PROJECT PLANS FOR CONSTRUCTION ON
STATE HIGHWAY
IN EL DORADO AND PLACER COUNTIES AT AND NEAR TAHOE CITY FROM 0.2 MILE SOUTH OF THE EL DORADO/PLACER COUNTY LINE TO THE TRUCKEE RIVER BRIDGE

4 REVISED PER ADDENDUM No. 4 DATED MARCH 2, 2012

CONTRACT No.	03-2A9204
PROJECT ID	0300000297

C-30

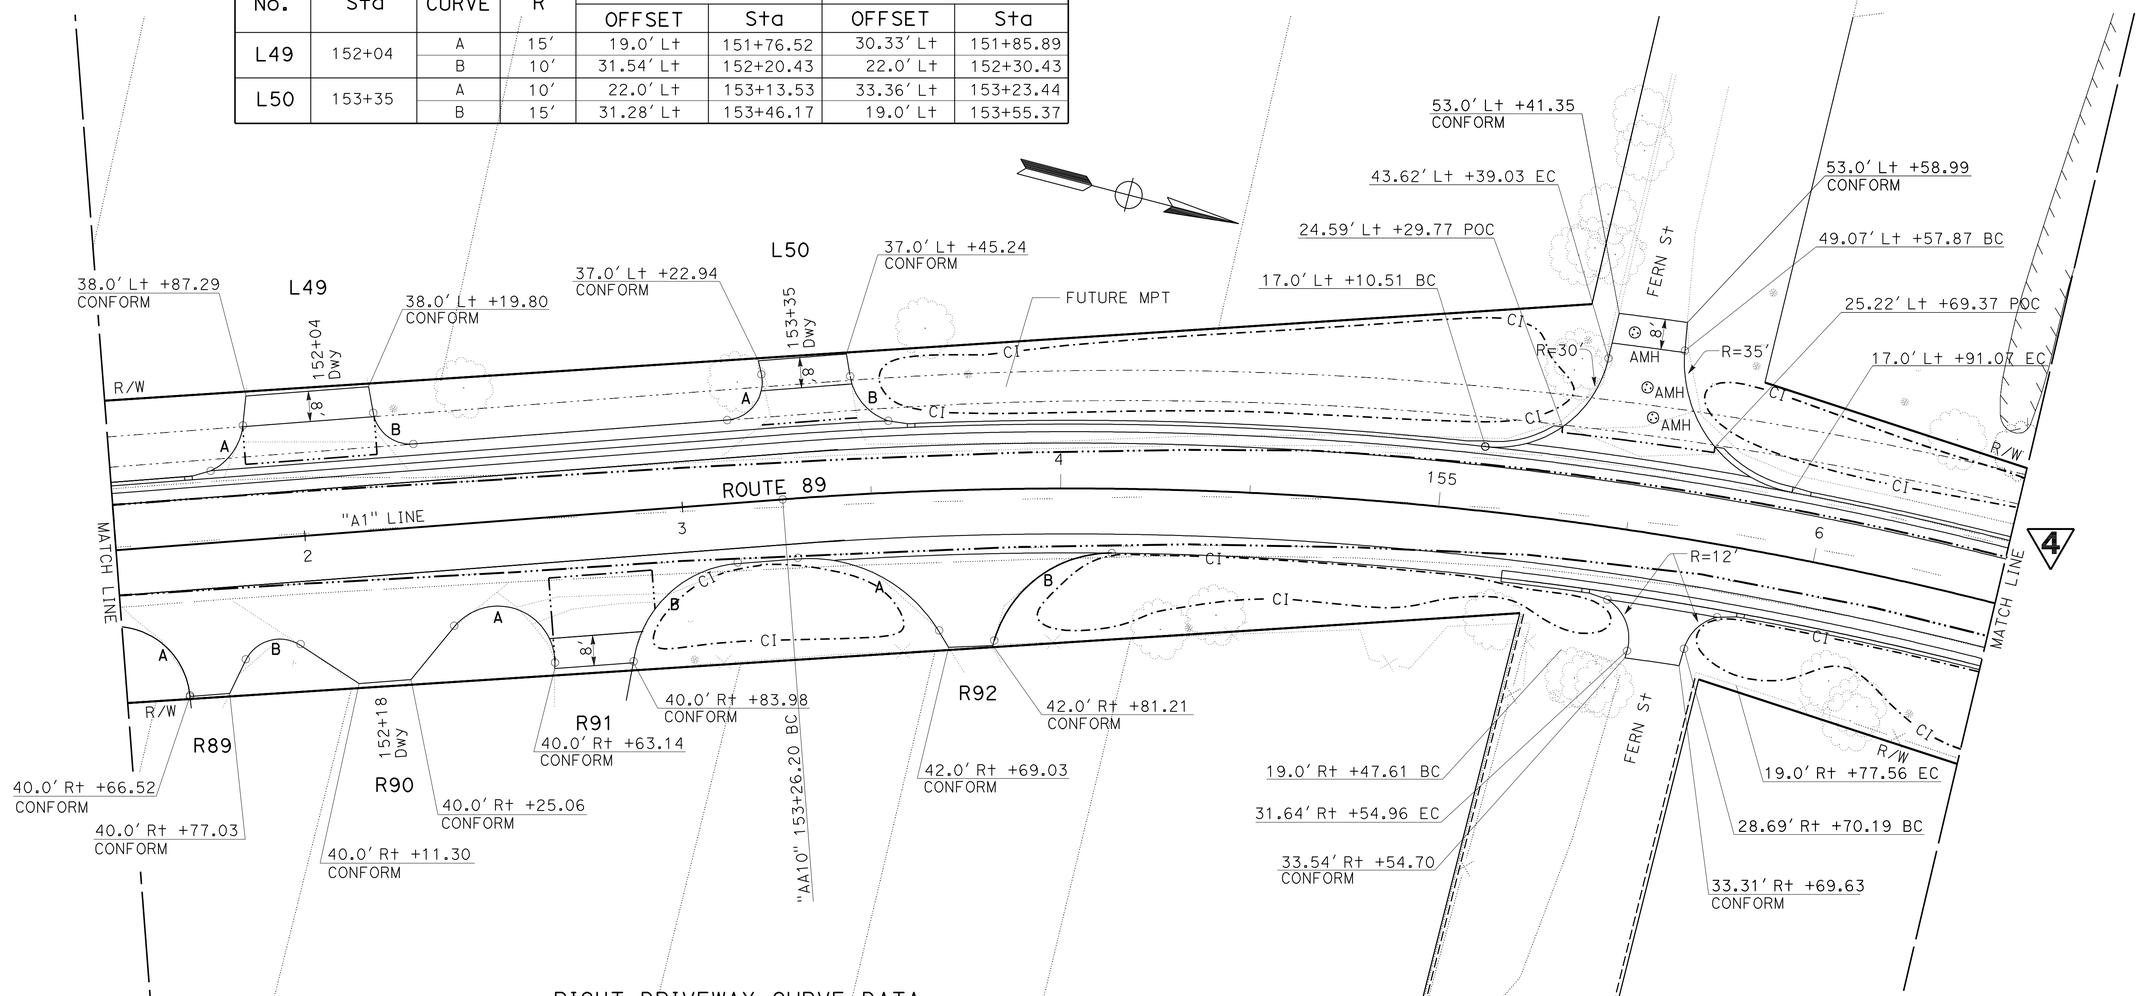
4 **REVISED PER ADDENDUM No. 4 DATED MARCH 2, 2012**

2 **REVISED PER ADDENDUM No. 2 DATED FEBRUARY 2, 2012**

C-31

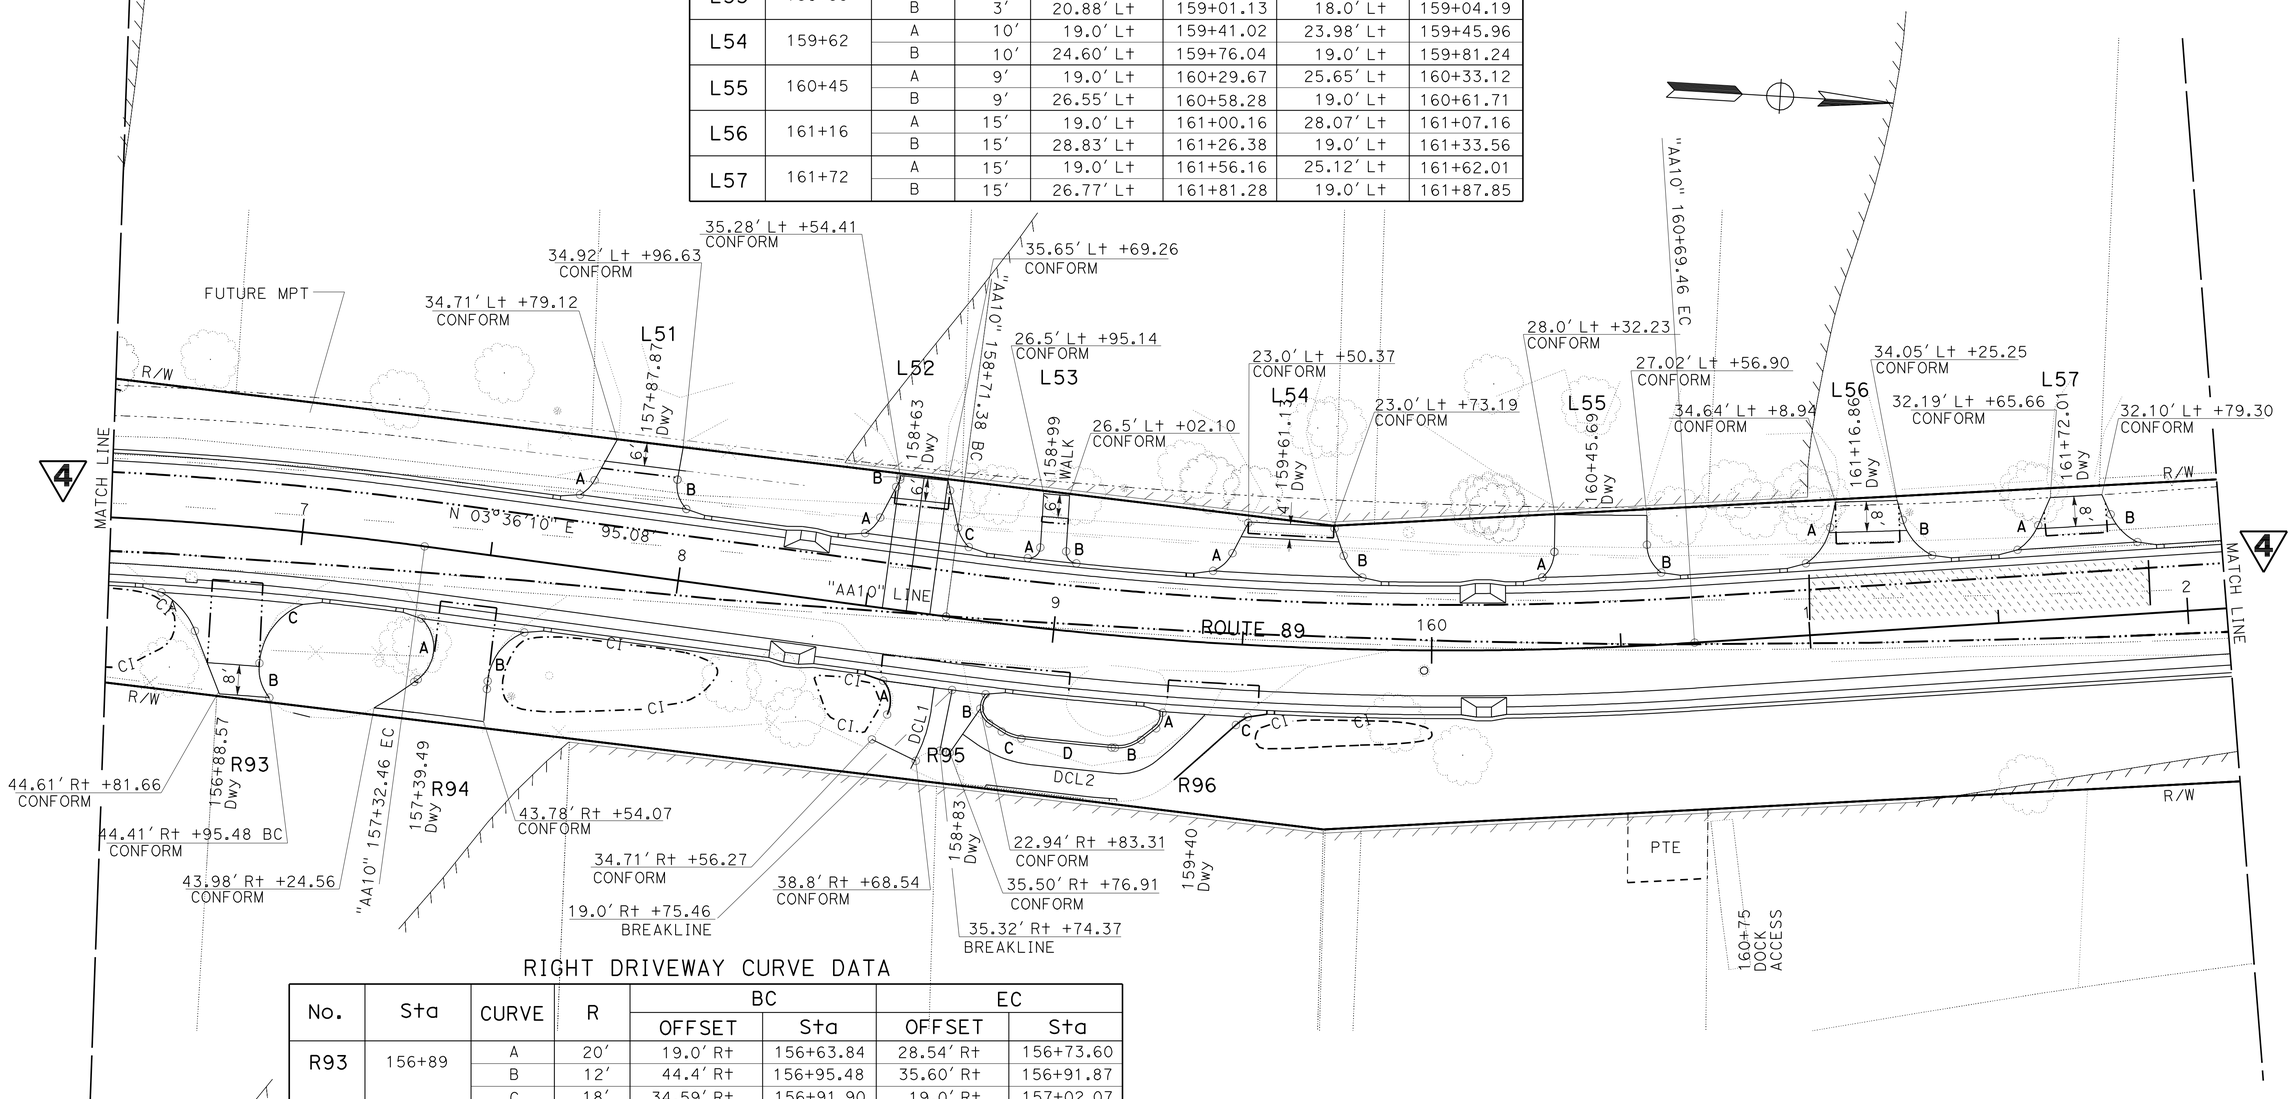
2 REVISED PER ADDENDUM No. 2 DATED FEBRUARY 2, 2012

4 REVISED PER ADDENDUM No. 4 DATED MARCH 2, 2012

C-32

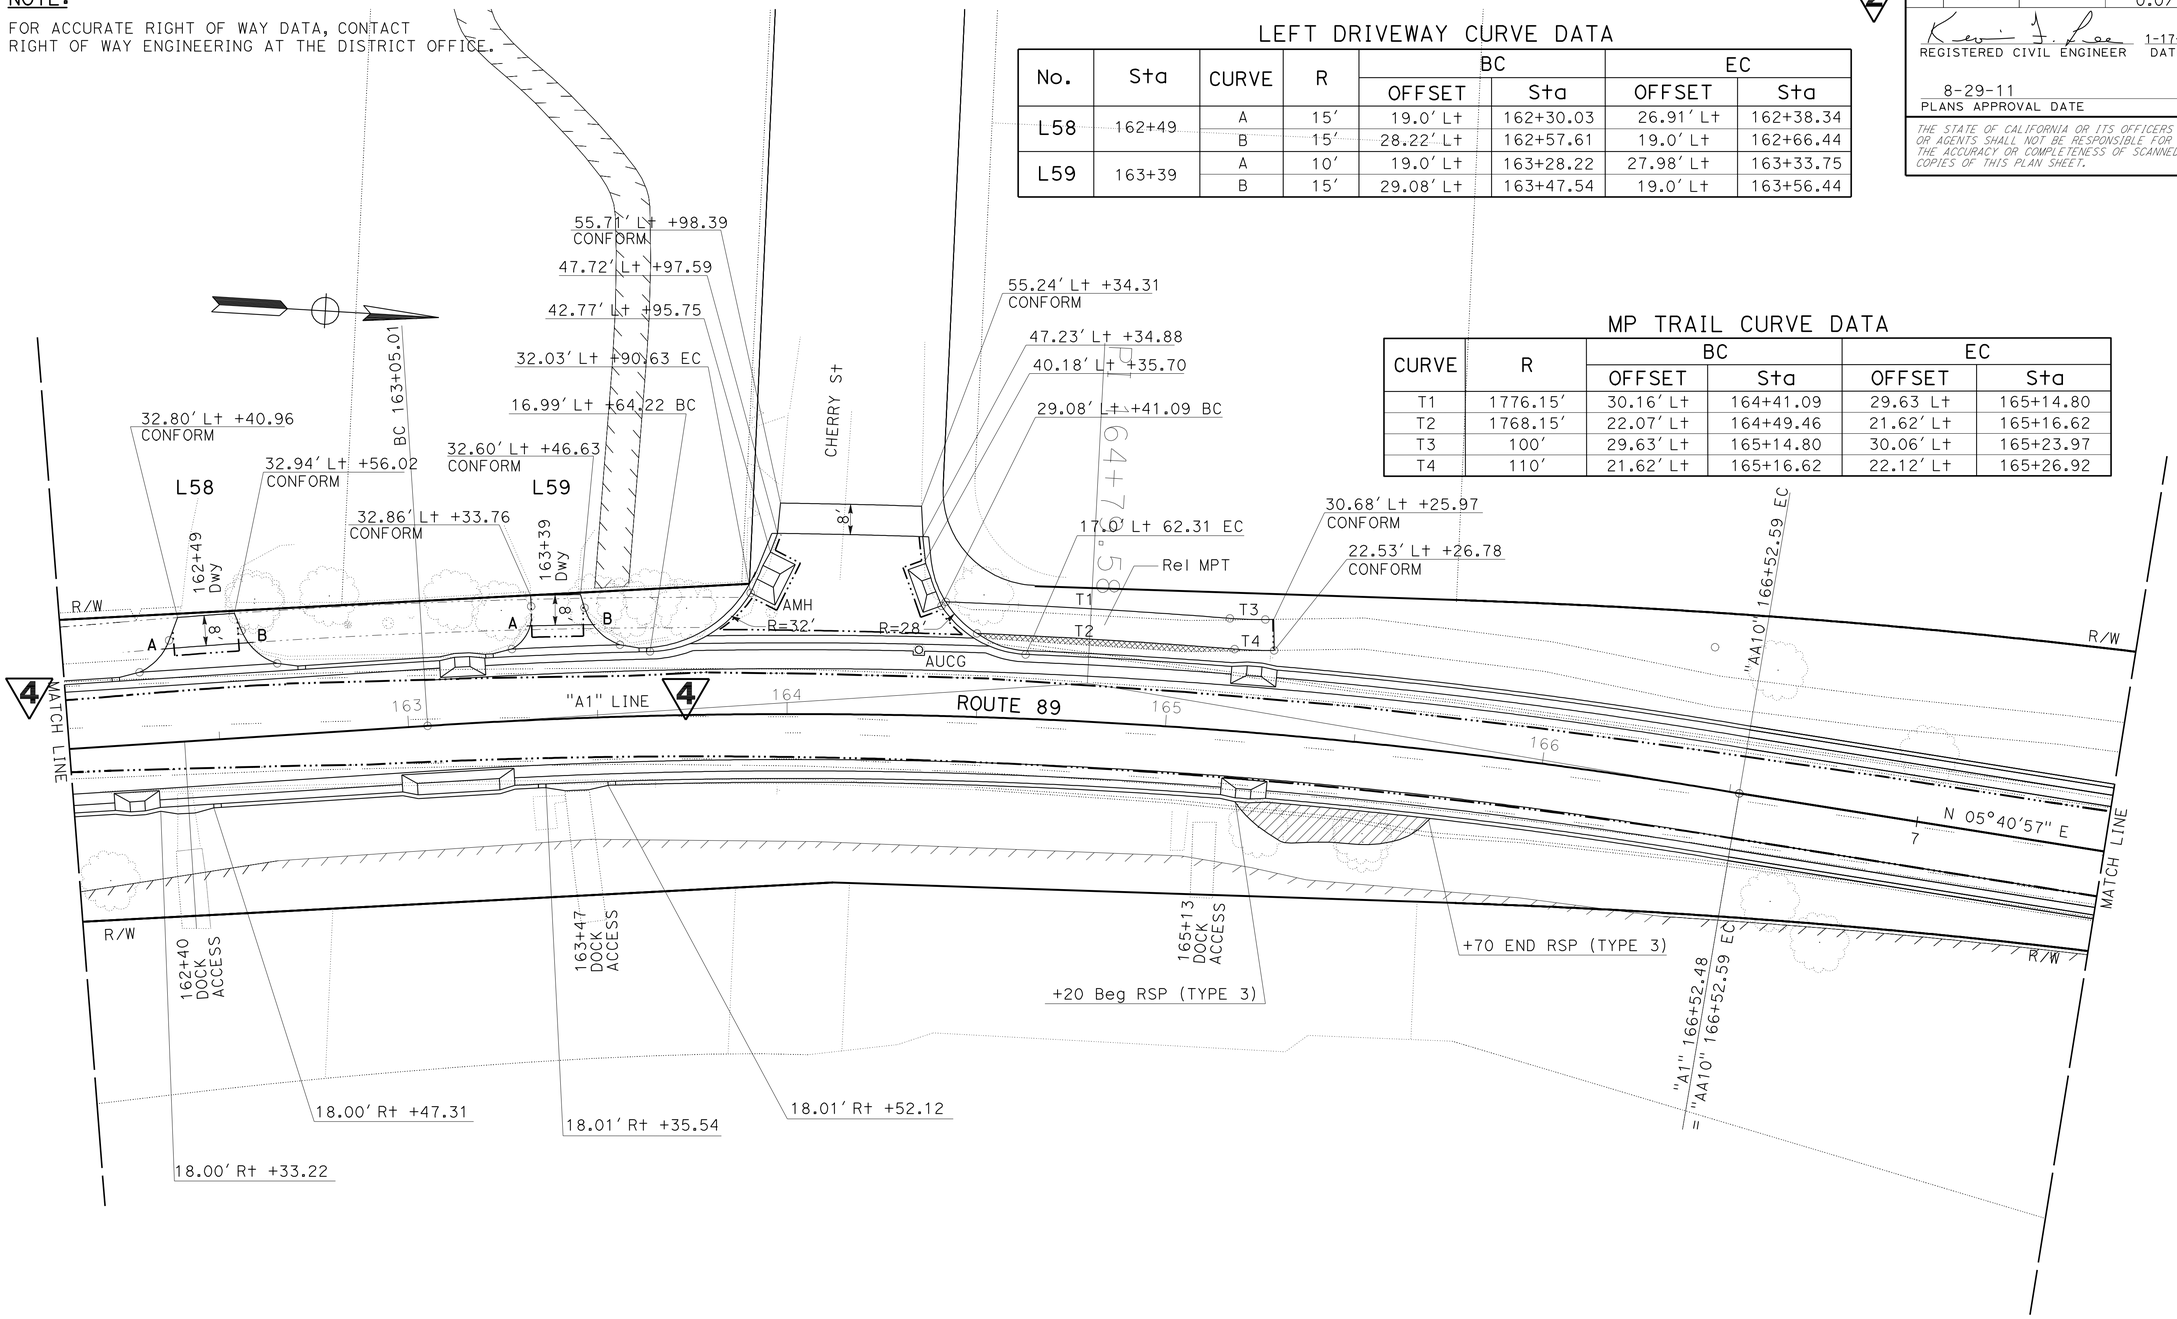
4 REVISED PER ADDENDUM No. 4 DATED MARCH 2, 2012

2 REVISED PER ADDENDUM No. 2 DATED FEBRUARY 2, 2012

IL DETAILS No. 1

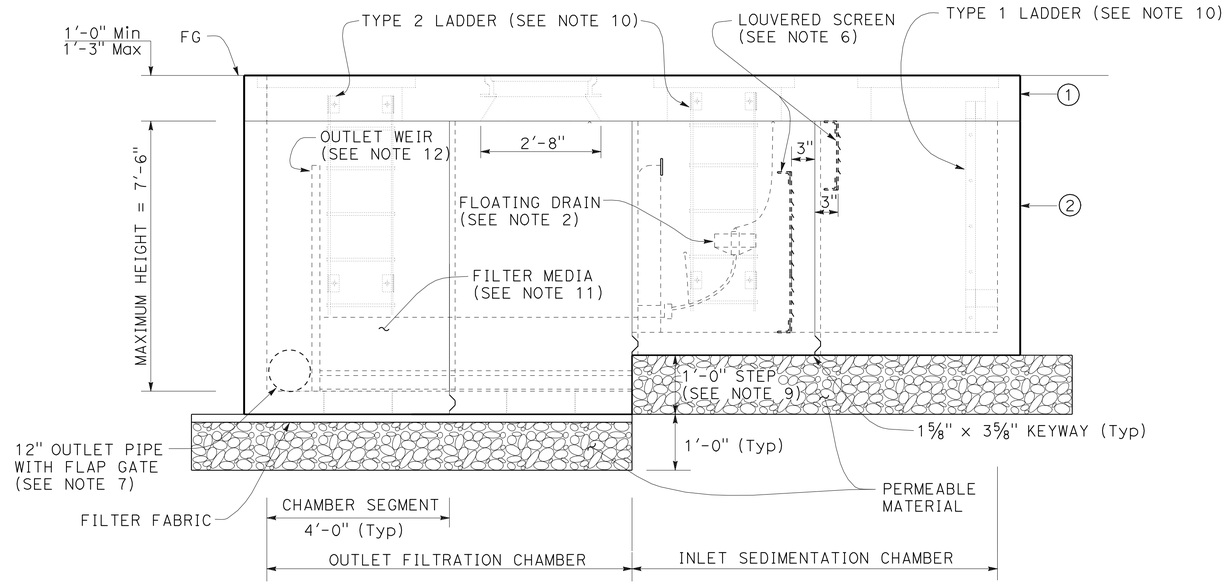
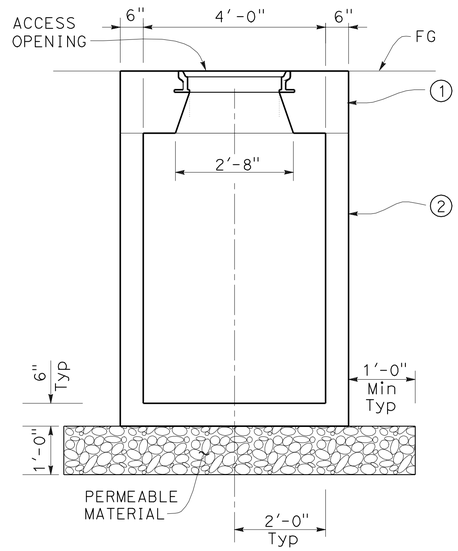
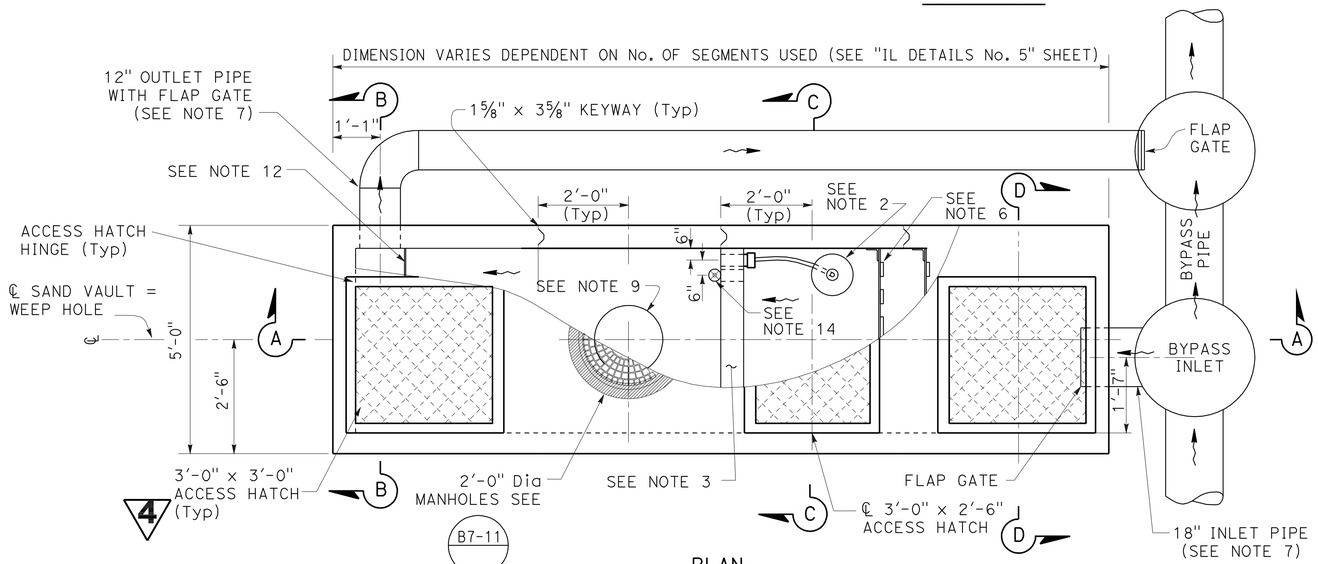
4 REVISED PER ADDENDUM No. 4 DATED MARCH 2, 2012

2 REVISED PER ADDENDUM No. 2 DATED FEBRUARY 2, 2012

SS DETAILS No. 1

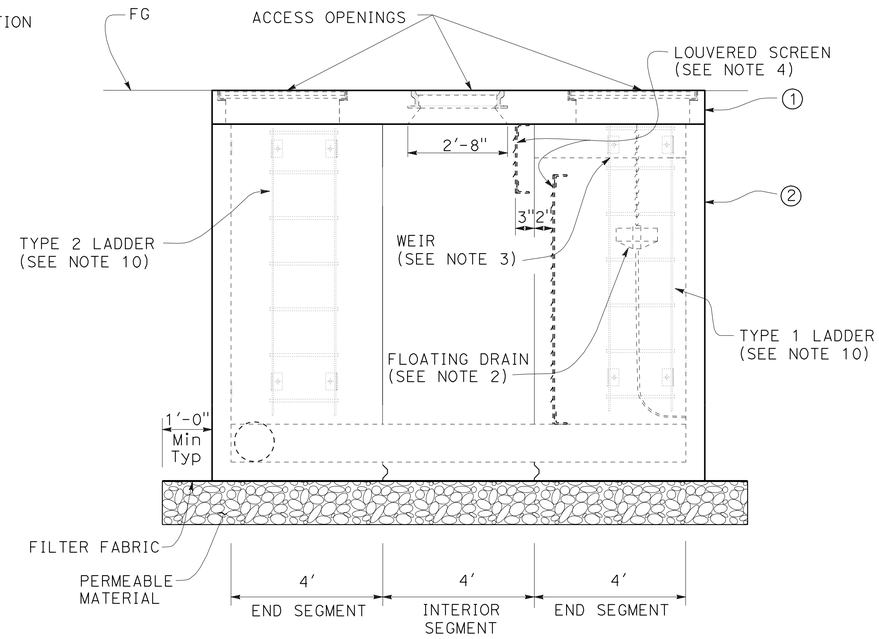
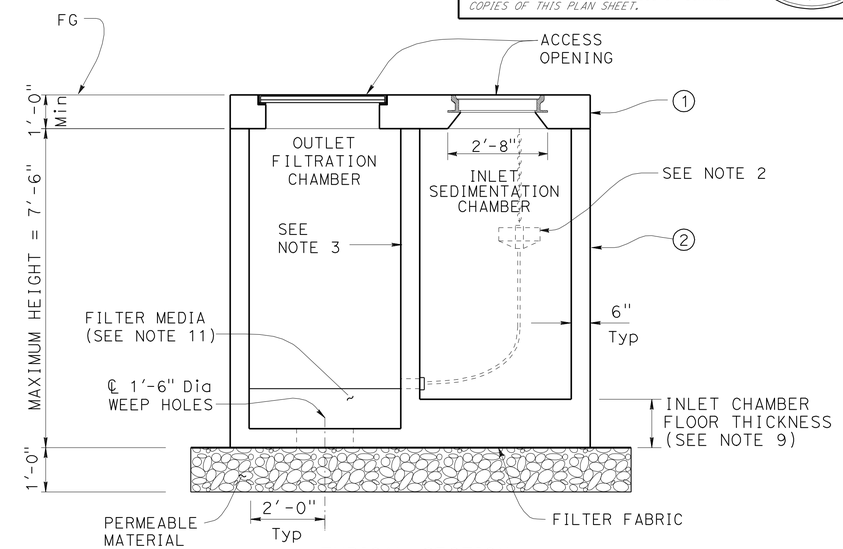
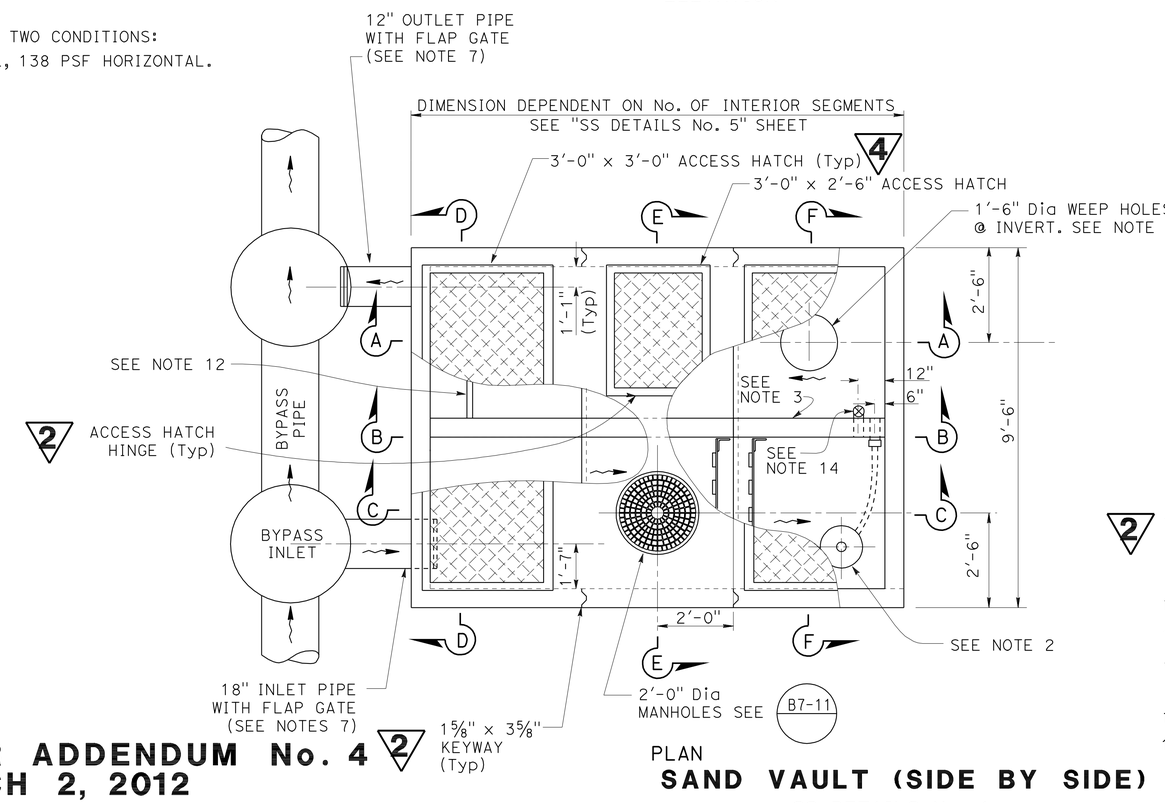
(4) **REVISED PER ADDENDUM No. 4 DATED MARCH 2, 2012**

(2) **REVISED PER ADDENDUM No. 2 DATED FEBRUARY 2, 2012**
